SERVICE BULLETIN MAINTENANCE OF WAY EQUIPMENT

MAINTENANCE OF WAT EQUI MENT					
DATE:	2-28-2002	BULLETIN NO: 02	2-005		
TITLE:	2004976 CLAMP CYLINDER ROD SEAL AND WIPER SERVICE GROUP				
RATING:	DIRECTIVE (Action Is Required)	ALERT (Potential Problem)			
	INFORMATION (Action Is Optional)	X PRODUCT IMPROVEMENT (Enhance Product)			
PRODUCT SERIES / MODEL: 6700S Tamper					
SERIAL NO:	All Models Serial # 152700 thru 152	2990			
SUMMARY:	A new one-piece cylinder head incorporating a new design wiper and seal has been tested extensively and implemented at the Ludington, MI. facility for Clamp Cylinder part # 431499-1. The new rod seal and wiper are offered in a new one-piece Cylinder Head Assembly part # 2004976. This assembly replaces the original two-piece cylinder head.

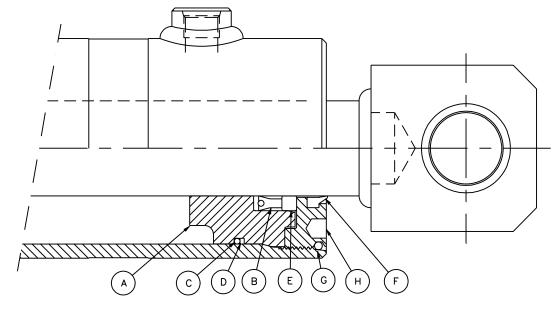
- 3. Remove the clamp cylinder from the machine.
- 4. Thoroughly clean the clamp cylinder. Then dis-assemble the clamp cylinder to remove the existing two-piece head, seals, o-rings, wiper, etc. as shown in Figure 1.
- 5. Re-assemble the clamp cylinder with the new one-piece head, seals, o-rings, wiper, etc. as shown in Figure 2 and Figure 3.

FIGURE 3 **NEW CYLINDER HEAD ASSEMBLY**

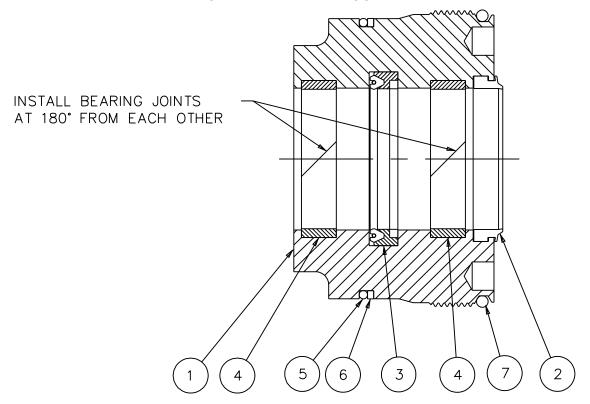
Note: Be sure to install the bearing joints at 180° from each other as shown in Figure 3.
